# City of Lindsay

### Tulare Road & Foothill Avenue Intersection and Pavement Rehabilitation Improvements Project 2024-03

#### Addendum/Clarification No. 1

FDR-C SECTION

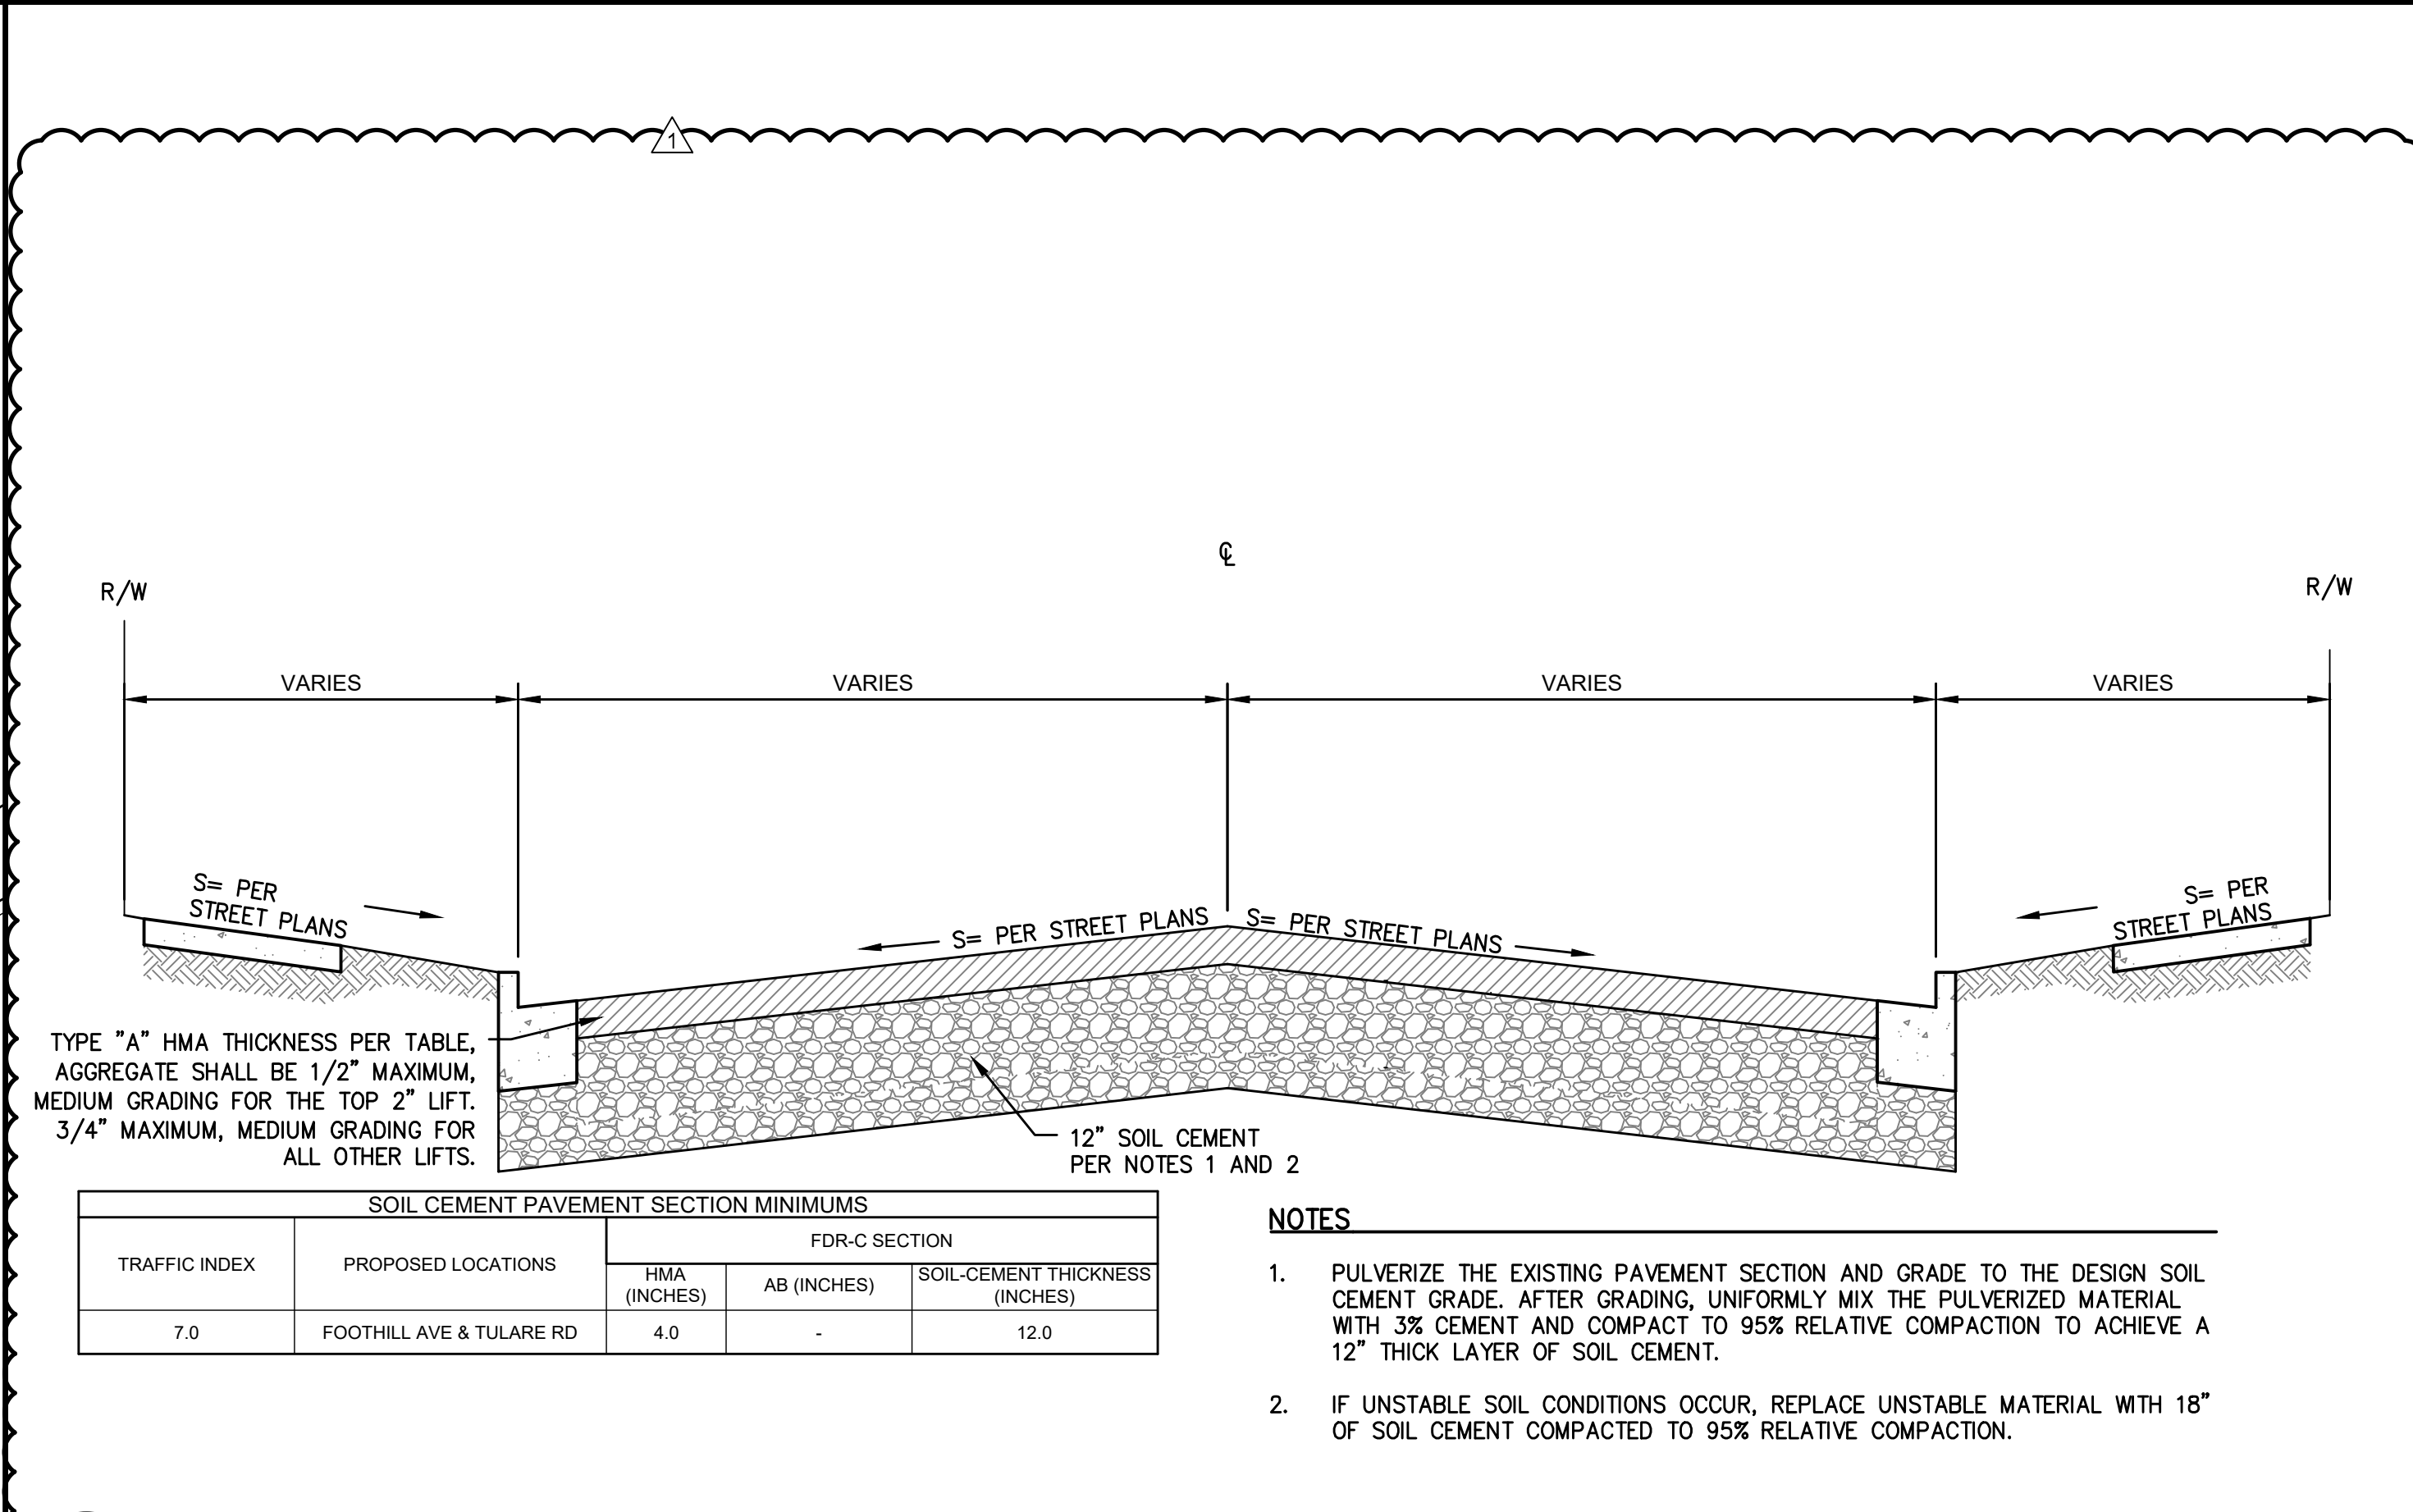
- a. Sheet X3: Modifications to Detail 3, FDR- C Section detail, new AC thickness of 4 inches.
